UNITED STATES PATENT AND TRADEMARK OFFICE

Office Action Summary

10/705,597

DETAILED ACTION

FIG.9

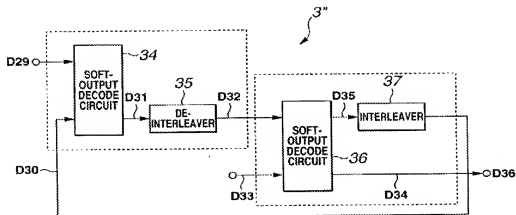
As per claim 1, Miyauchi substantially teaches a decoder for a communication system (i.e., Figure 1), the decoder comprising: a first decoder block (i.e., Figure 9, reference number 34 and paragraph 0280-0281) that receives a soft-input information bit for decoding and calculates a probability estimate for the soft-input information bit; a second decoder block (i.e., Figure 9, reference number 36 and paragraph 0280-0284) configured to receive and process the probability estimate of the soft-input information bit; and a decision module adapted to receive the processed soft-input information and to generate hard-decision output information (i.e., paragraph 0909).

Miyauchi does not explicitly teach to perform modulo arithmetic operations as stated in the present application.

As per claim 2, Miyauchi substantially teaches, in view of above rejections, (i.e., Figure 9 and Paragraph 0281) the first decoder block includes an output element configured to receive the soft-input information bit and to generate extrinsic information.
